PLAN NUMBER
MCKINNEY

2563 HILLMAN GROVE ROAD
THOMAS PROPERTIES

SHEET 1 of 1
S-1
STEM WALL
FOUNDATION PLAN

Per your request, the McKinney residence plan was reviewed to address several framing issues. Analysis of these areas revealed the following:

LEFT SIDE ELEVATION
SCALE 1/4"=1'-0"

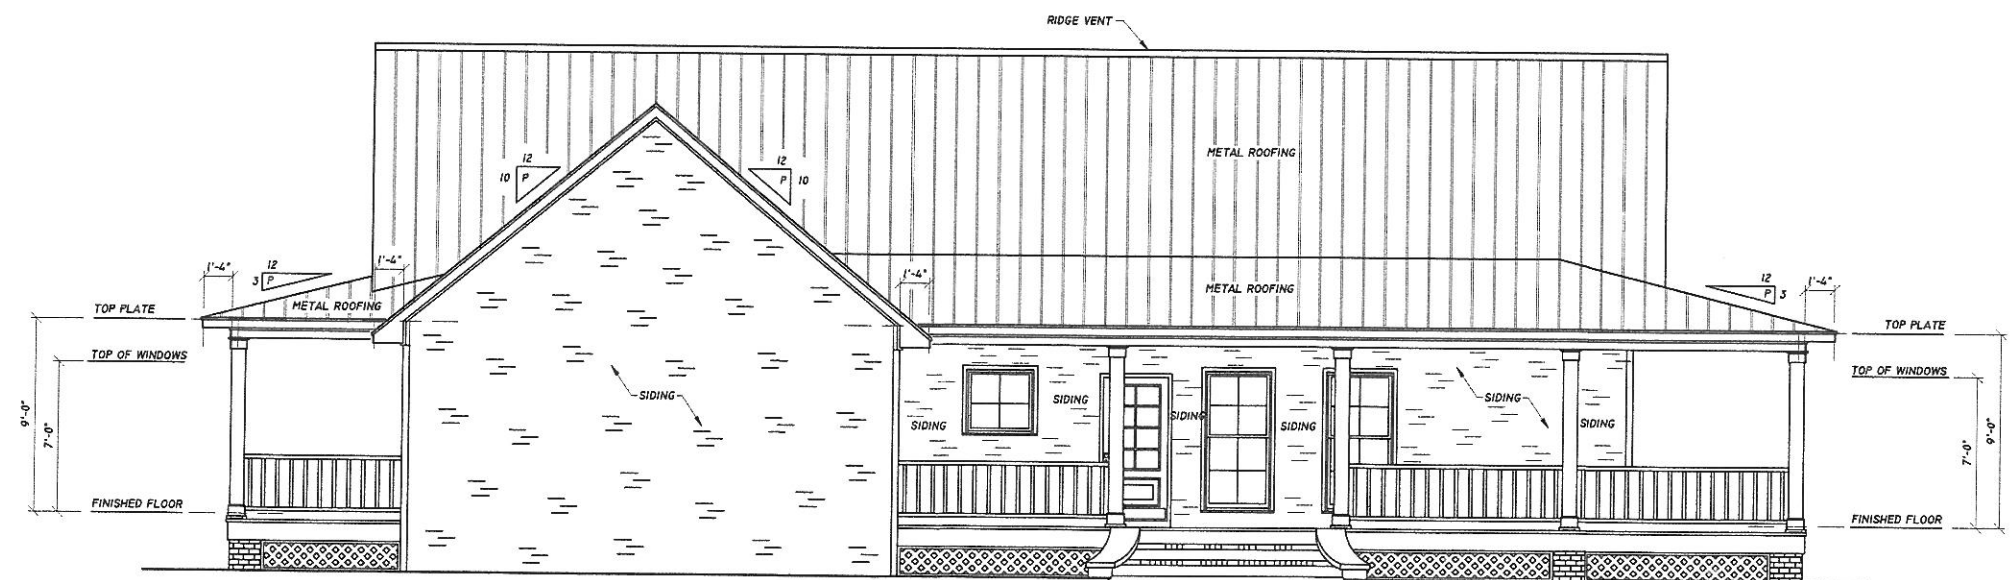
- 9) The left porch posts on the left elevation cannot exceed a maximum span of 13'-0". All left porch beams are to be (2) 2 x 10 supports by 4 x 4 treated posts (minimum).

REAR ELEVATION
SCALE 1/4"=1'-0"

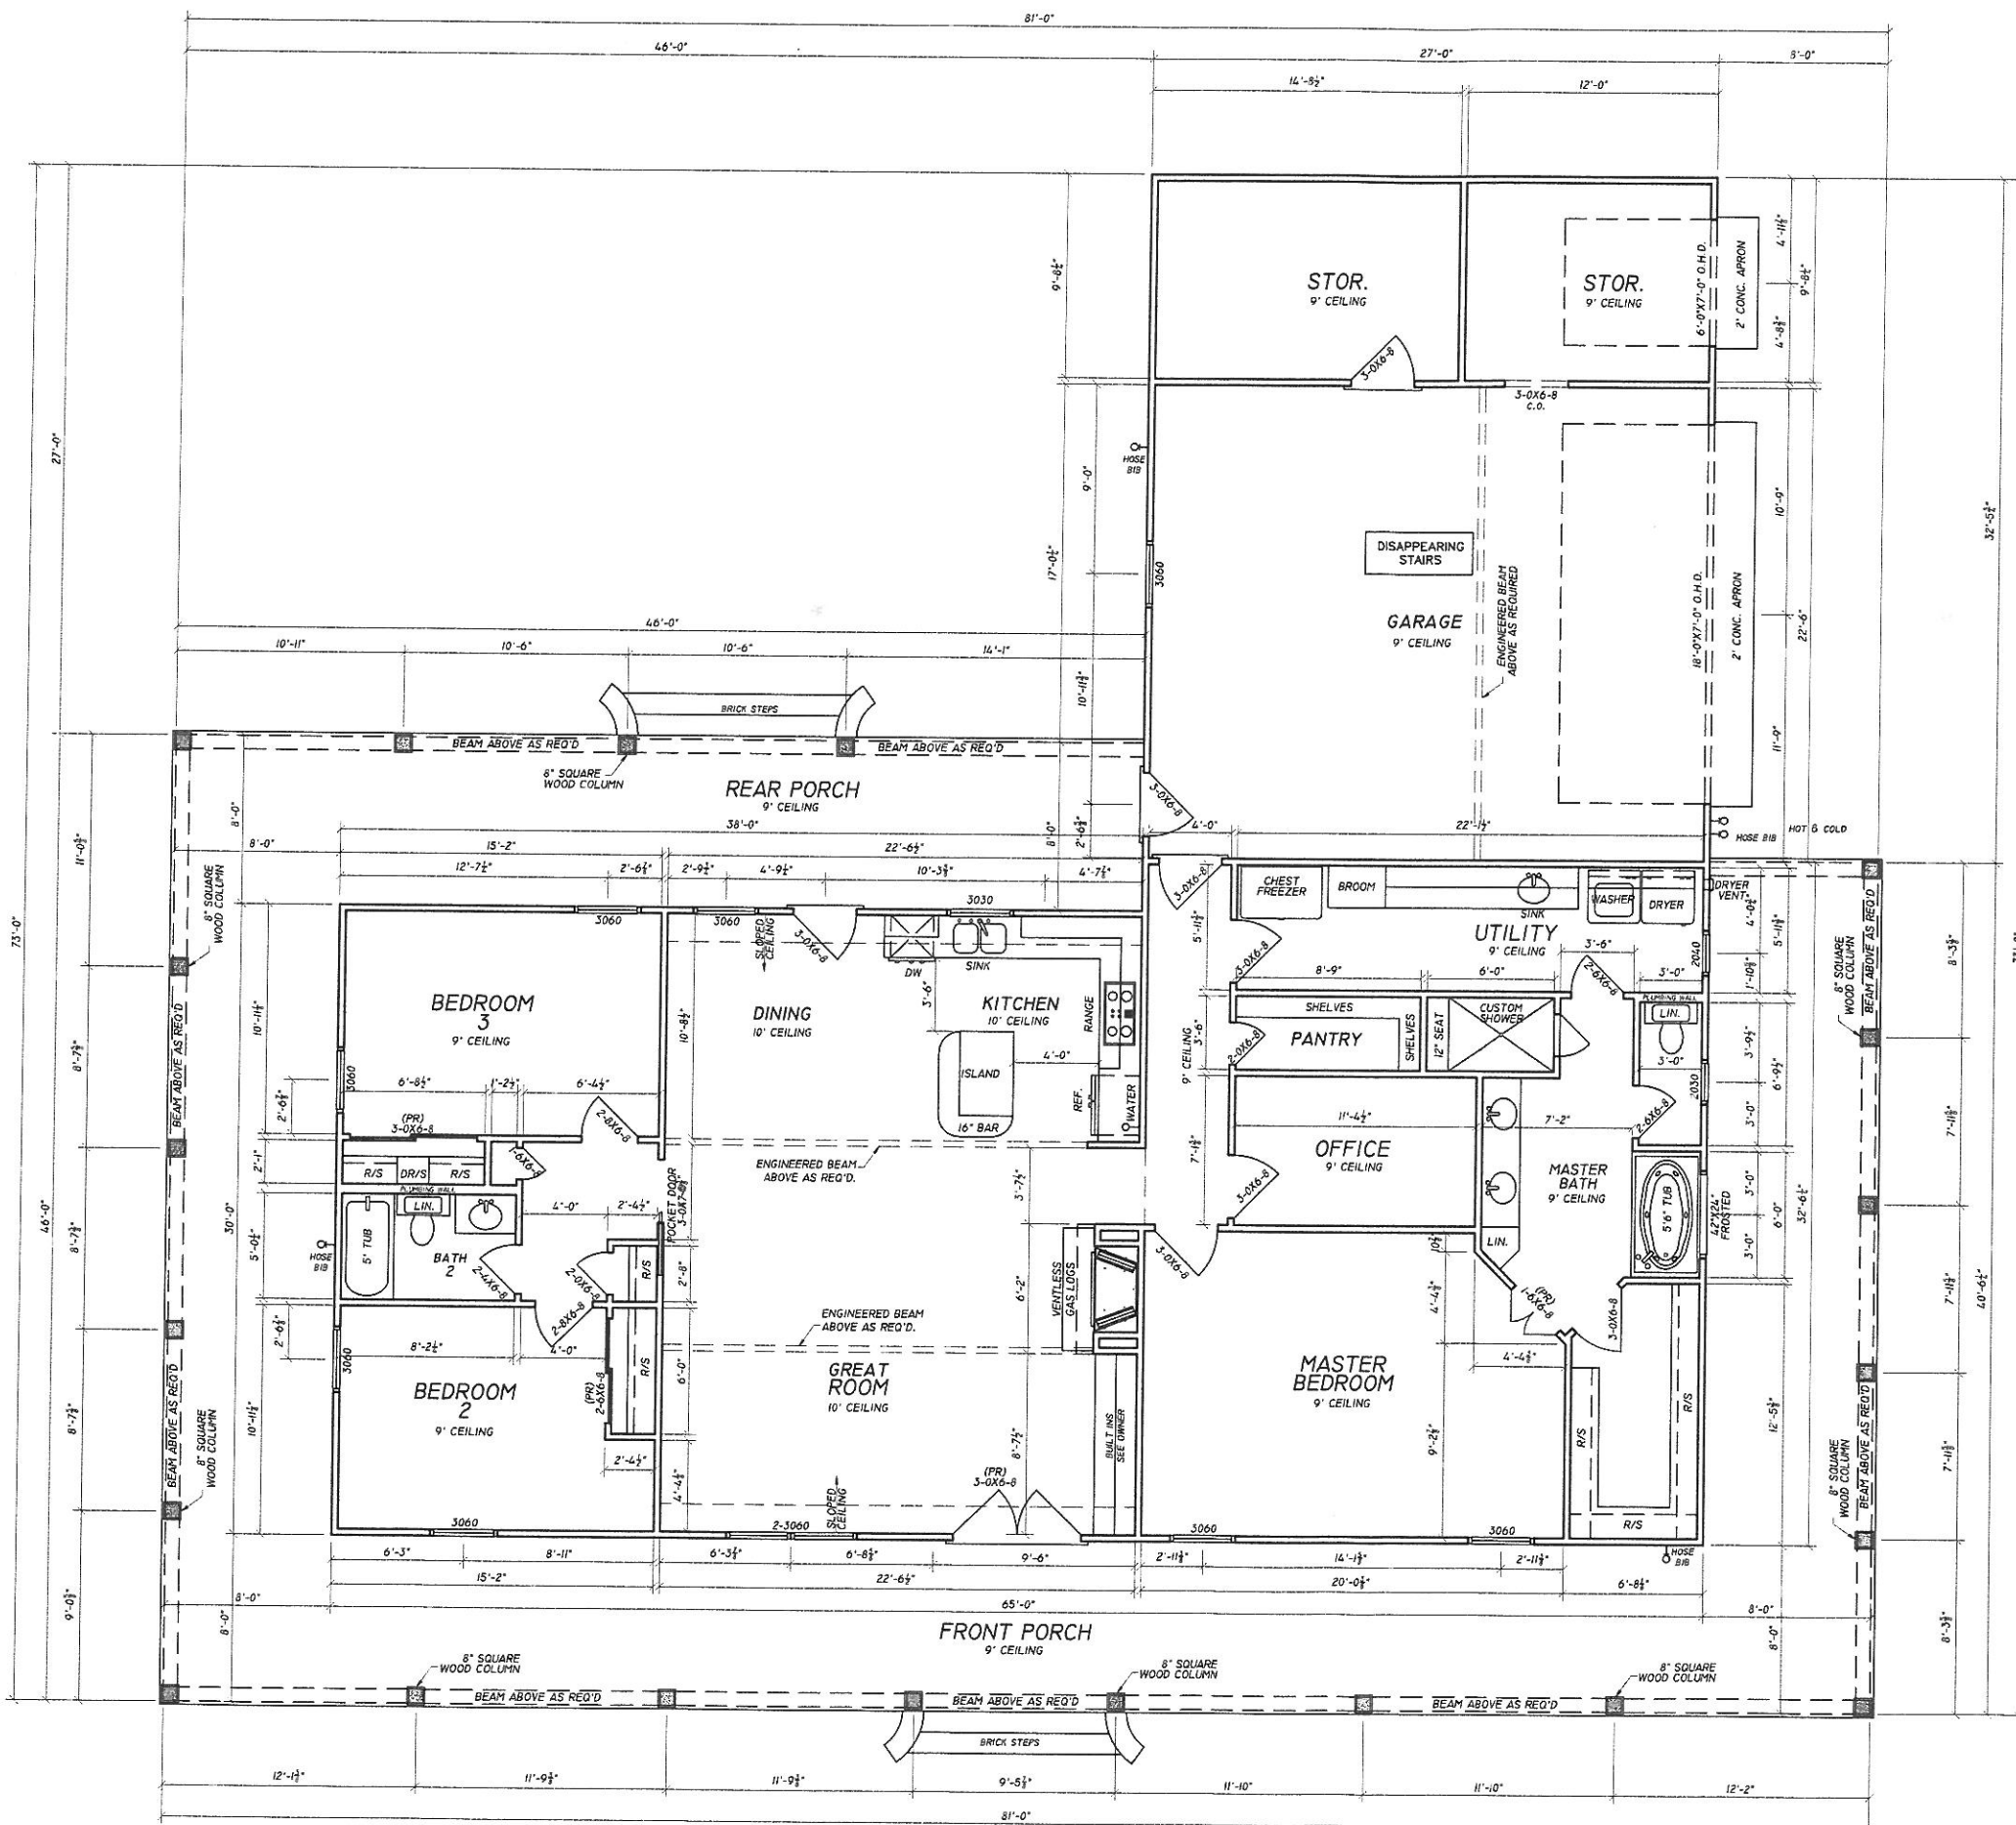
- 10) The rear porch posts at the rear elevation are to be re-spaced and cannot exceed a maximum span of 13'-0". All rear porch beams are to be (2) 2 x 10 supported by min 4 x 4 treated posts.

FLOOR PLAN
 SCALE 1/4" = 1'-0"

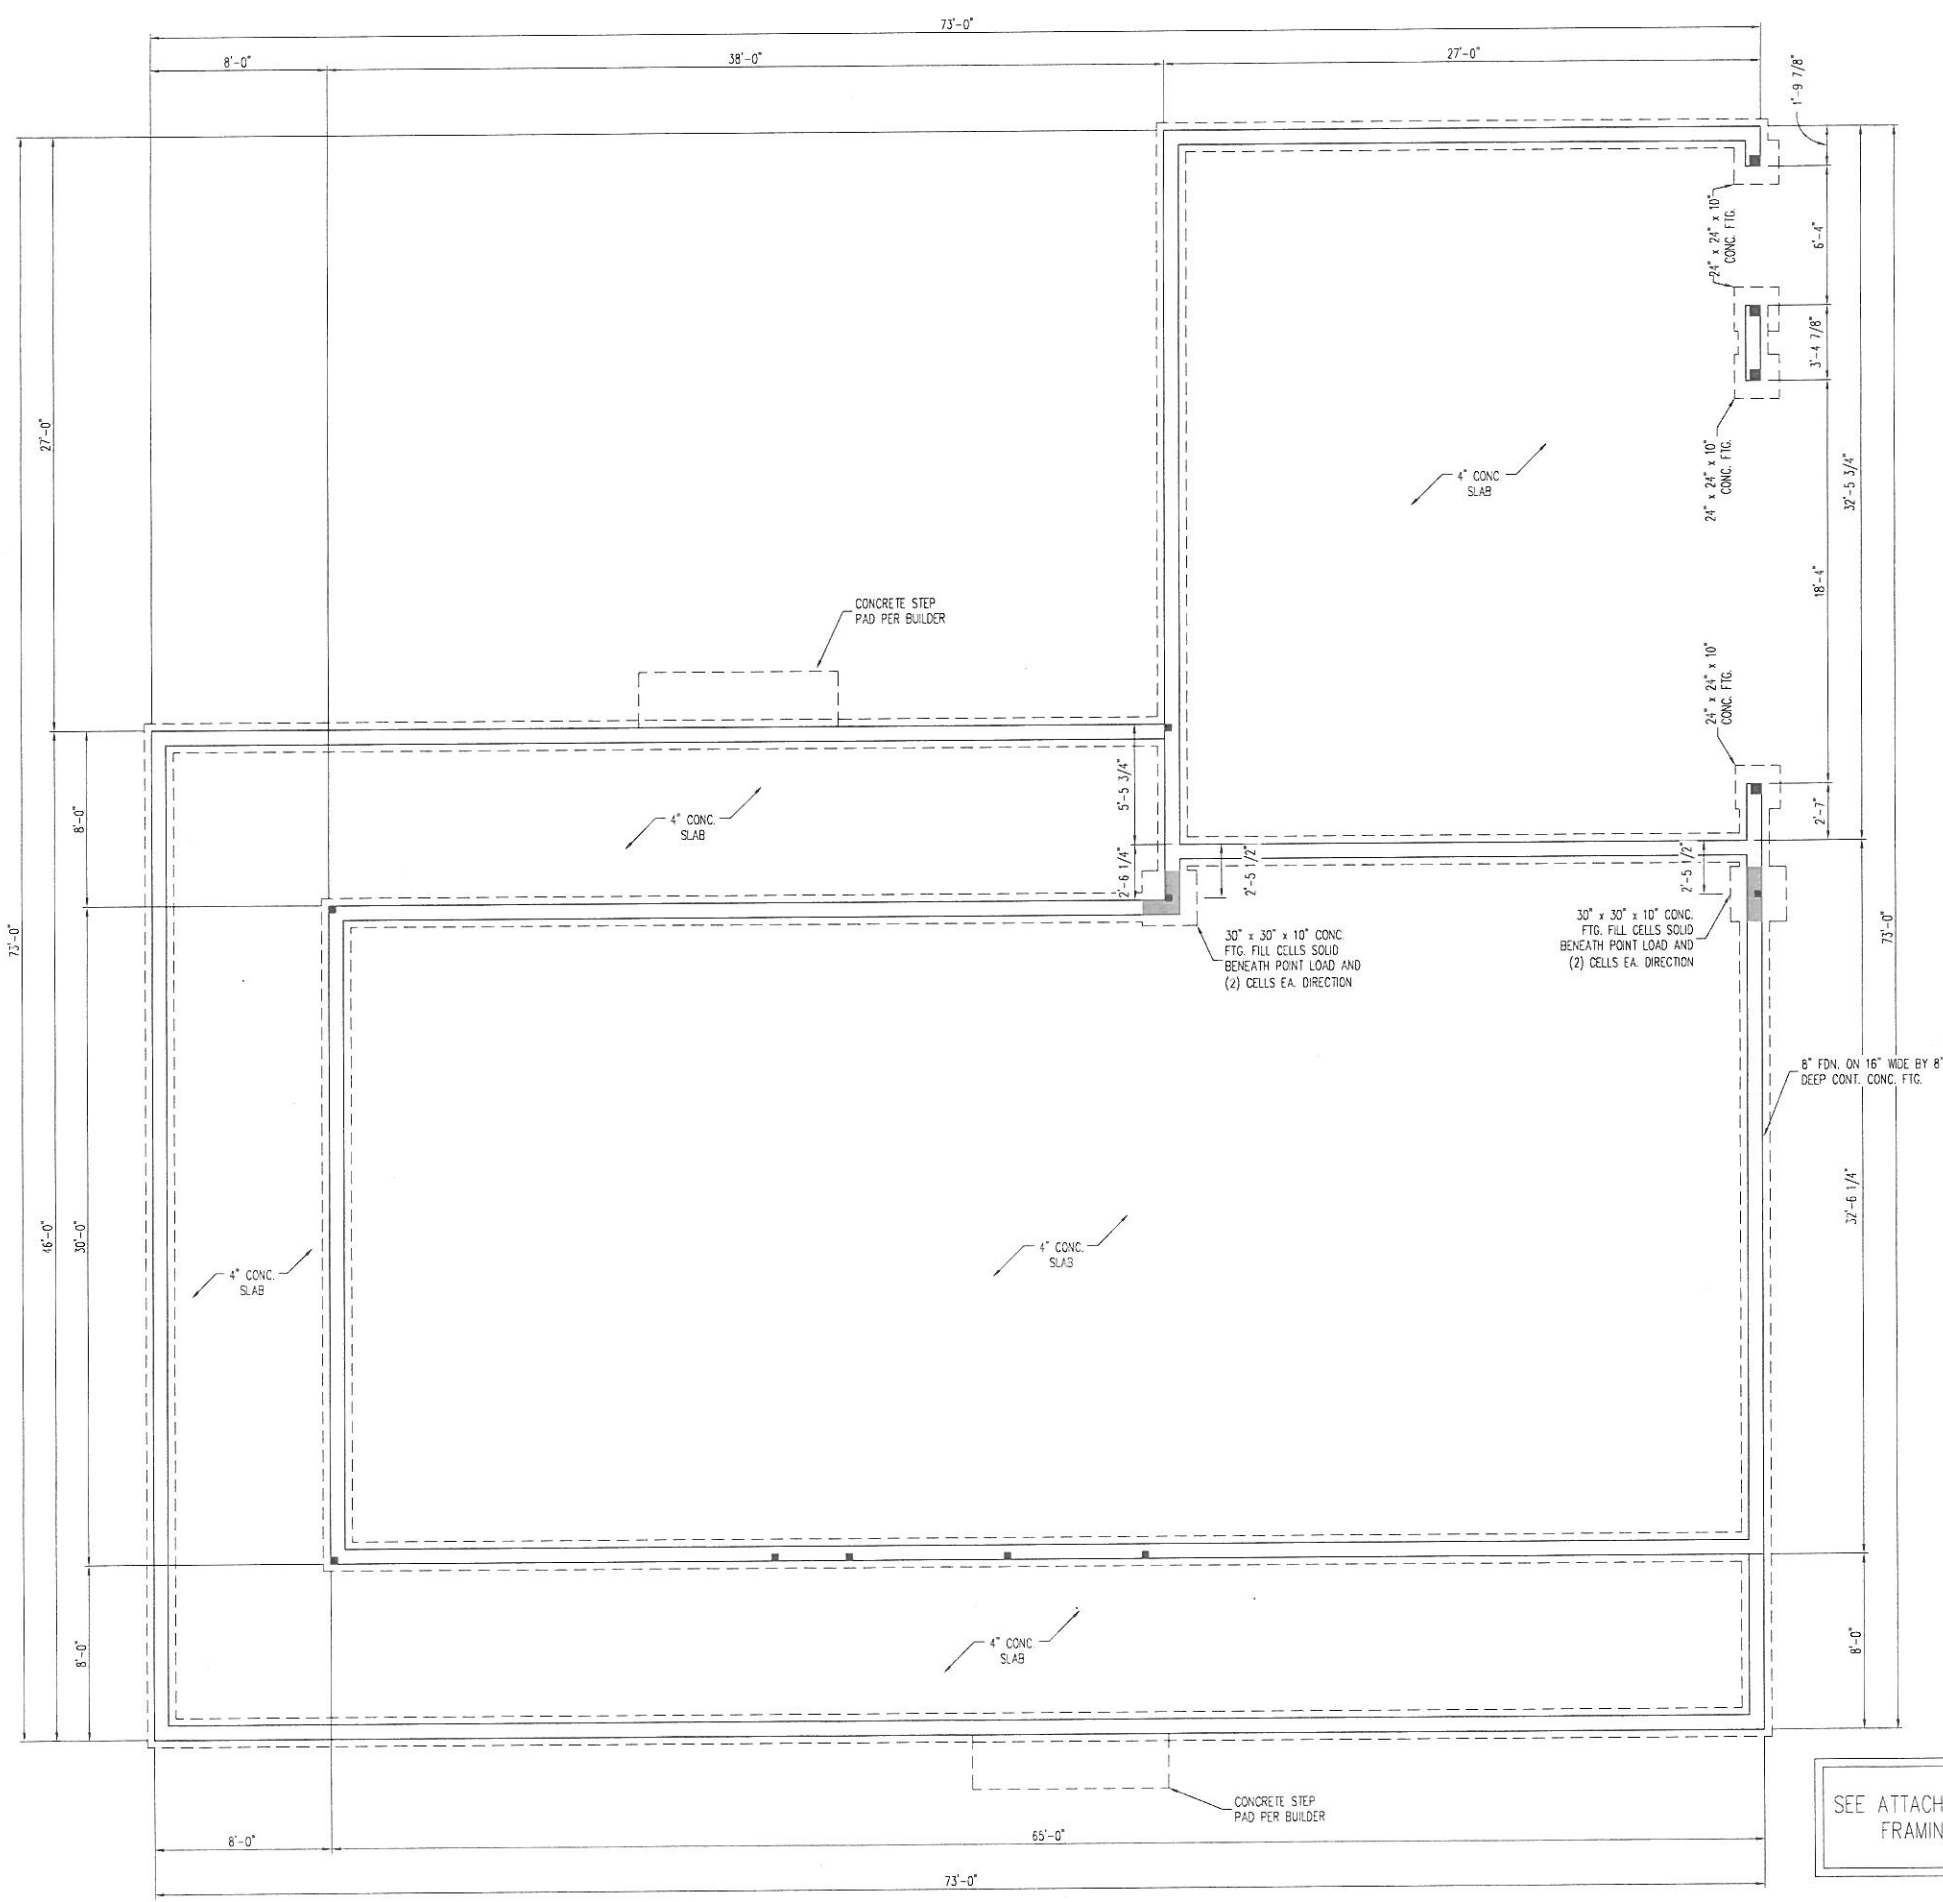
- 2) The structure's width increased by 8'-0" along the rear garage and shared great room and master bedroom wall. This change resulted in the garage, storage room, utility room, pantry, office, master bedroom, kitchen, and great room each becoming 4'-0" wider than the original plans. The porch at the right side of the master suite will not be constructed.

- 3) The items labeled "Engineered beam above as required" on sheet 2 of 6 of the McKinney plan are not to be installed and can be disregarded. The roof trusses engineered by others will span across the house to each exterior wall and there will not be any internal bearing points.

- 4) All dimensional lumber is to be SPF #2 unless noted otherwise.
- 5) The girder truss engineered by others labeled "B04G" is to be supported by (4) 2 x 4 at the kitchen wall and (5) 2 x 4 at the utility room exterior wall. The stud columns are the fastened with Simpson CS16 straps at 24" o.c.
